# CONTEXT MAP DERRYDOWN WAY SIDEWALK

# BENEFITS OF WATER QUALITY BASIN/PERMEABLE PAVEMENT DERRYDOWN WAY SIDEWALK

NOVEMBER 2023

# DERRYDOWN WAY SIDEWALK ALIGNMENT OPTION A

# BENEFITS OF SIDEWALKS DERRYDOWN WAY SIDEWALK

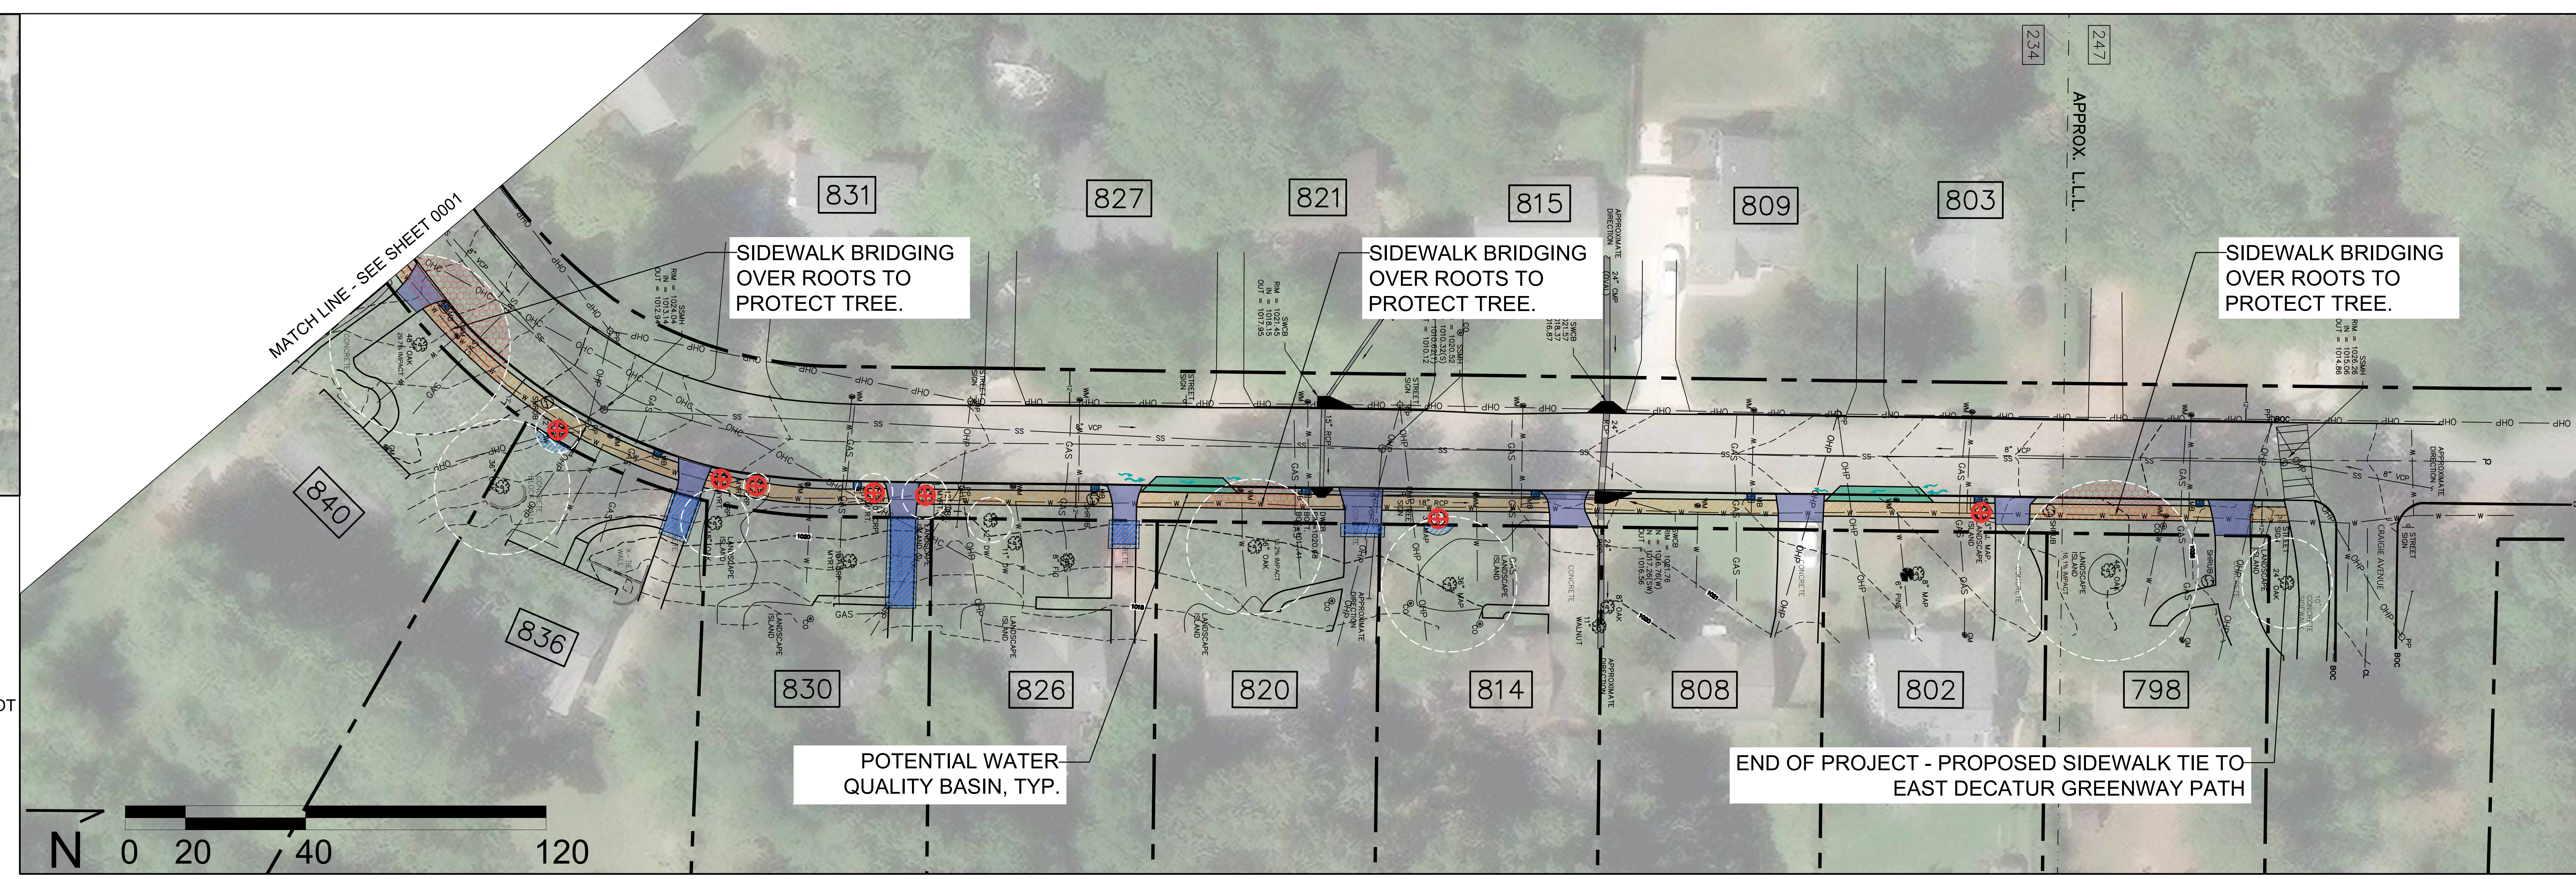
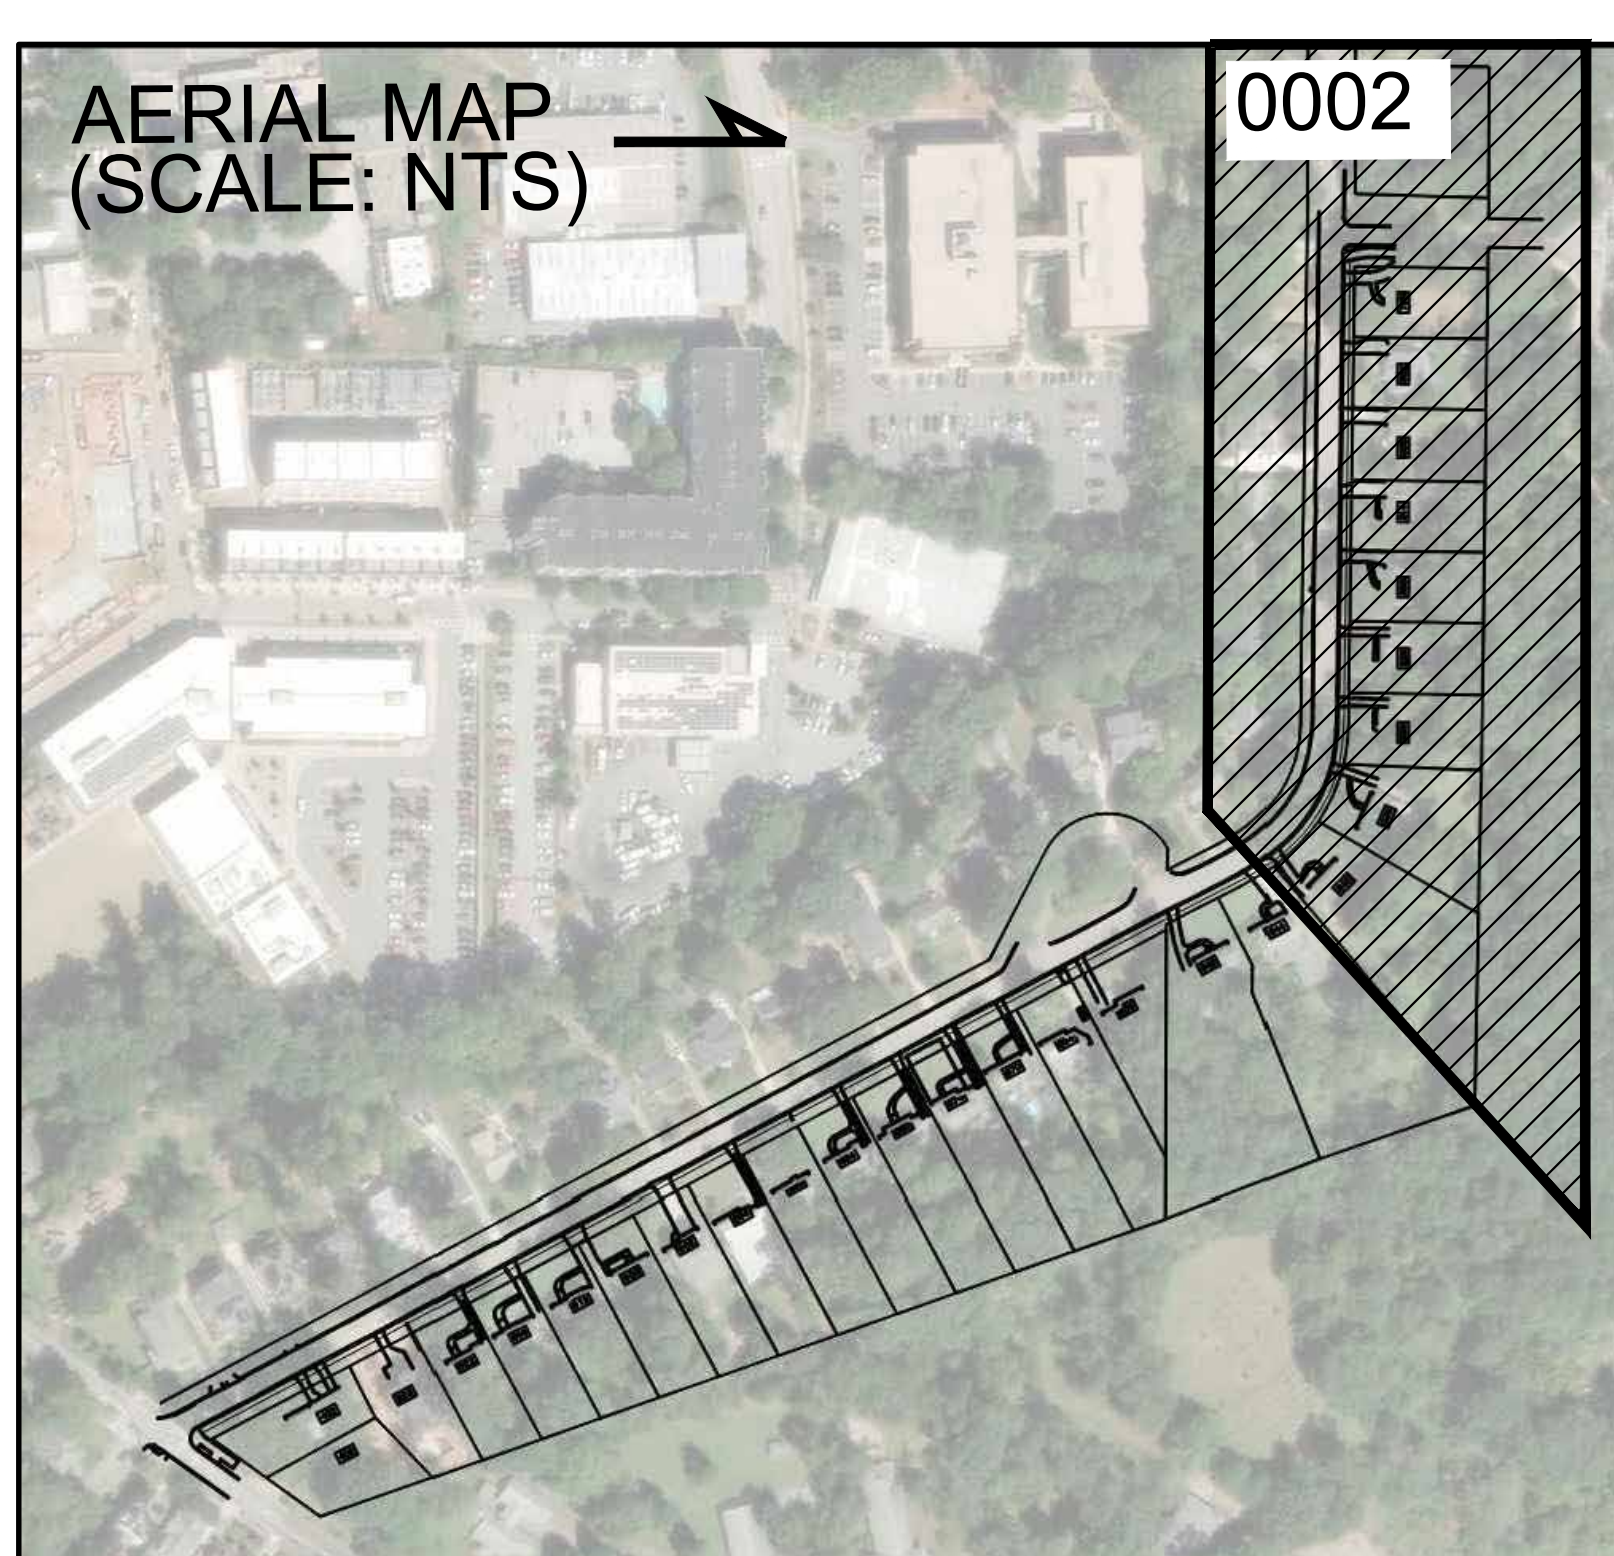
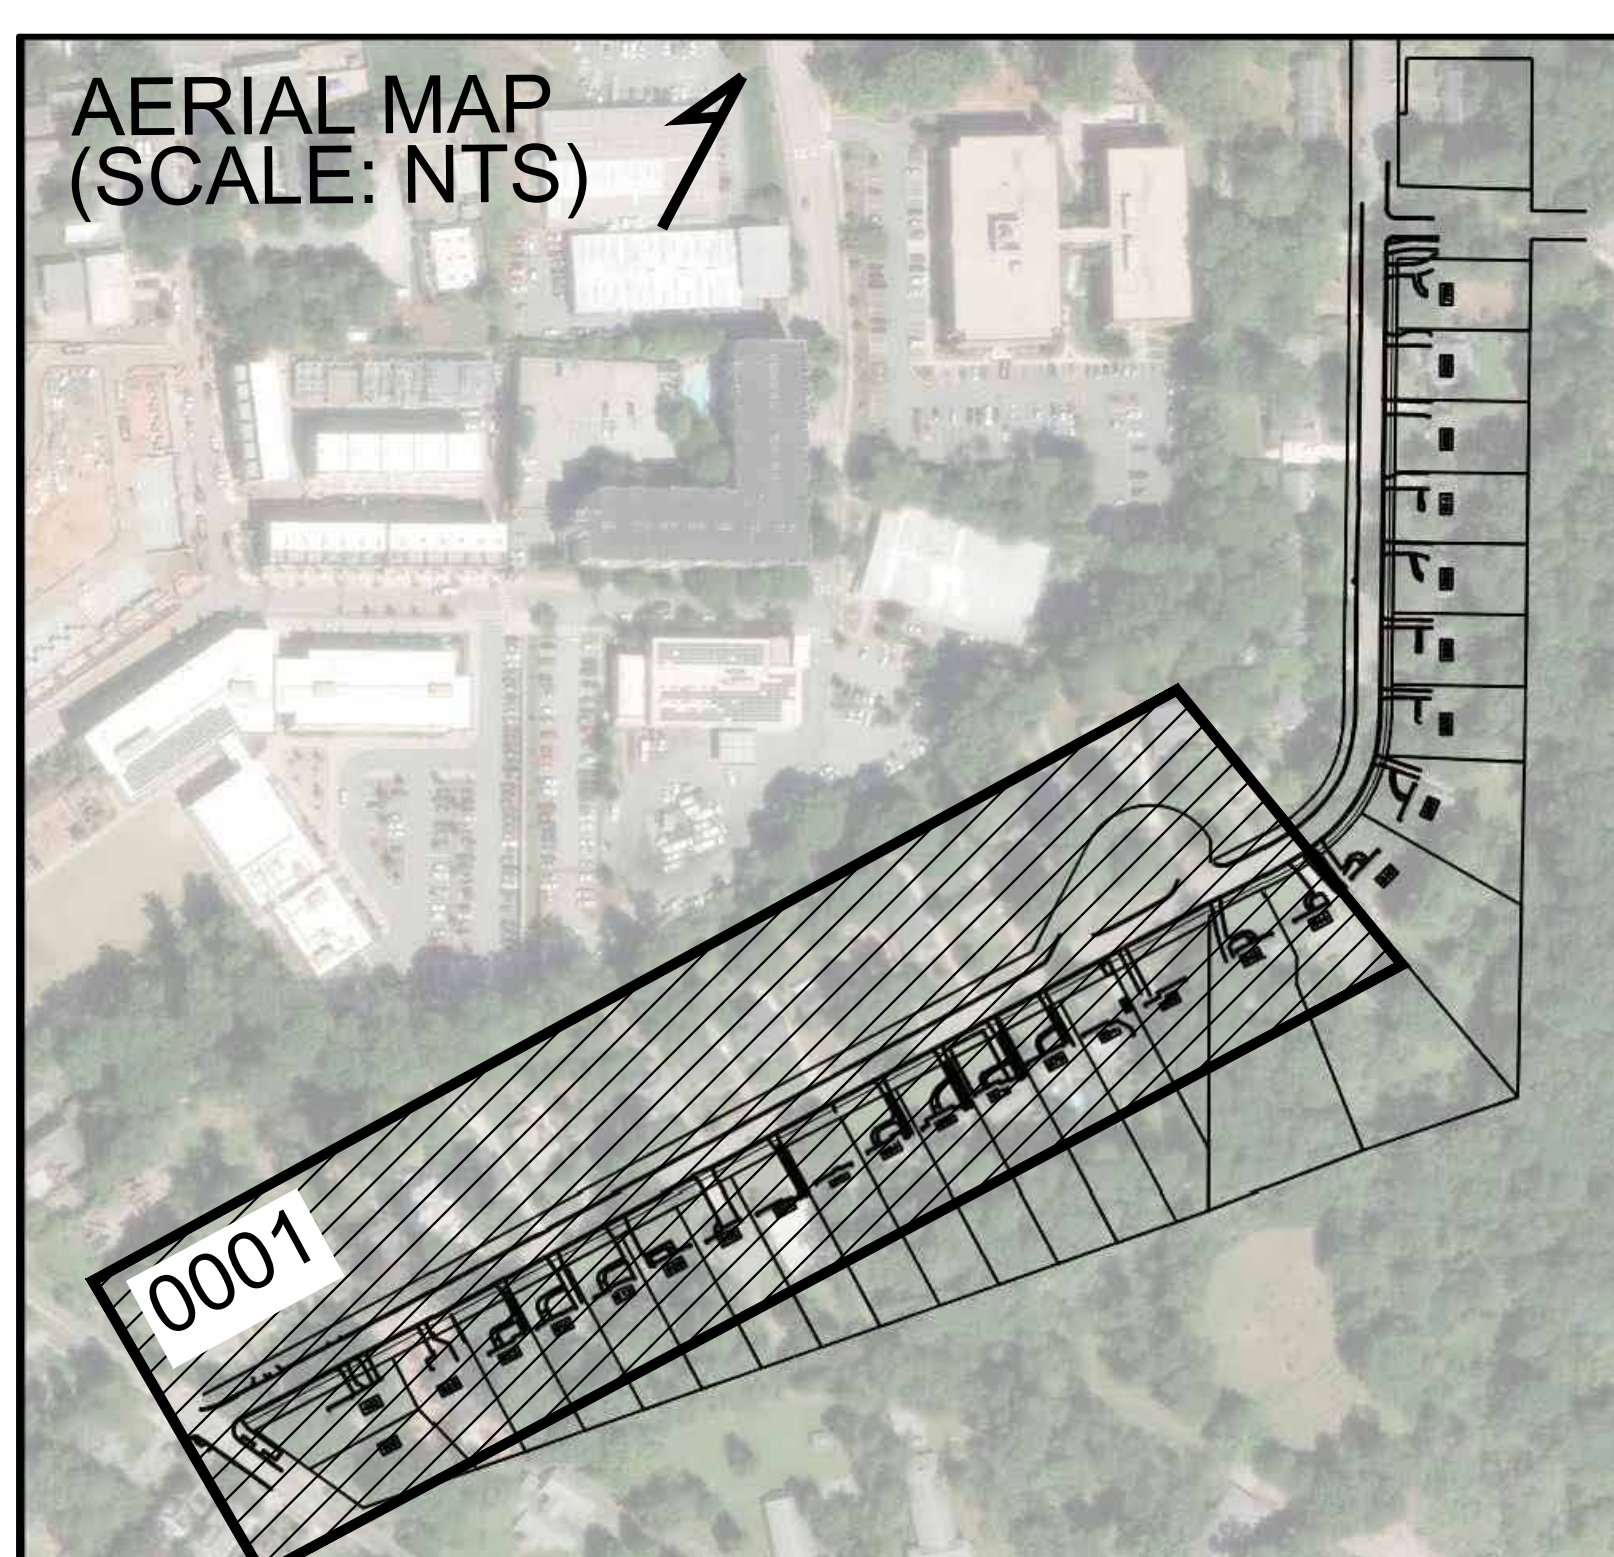
## “Many driveways would need to be reconstructed...”

Our response: This is correct. Many driveways would need to be reconstructed. The recommended South East alignment would require less intrusive reconstruction as the topography is flatter.
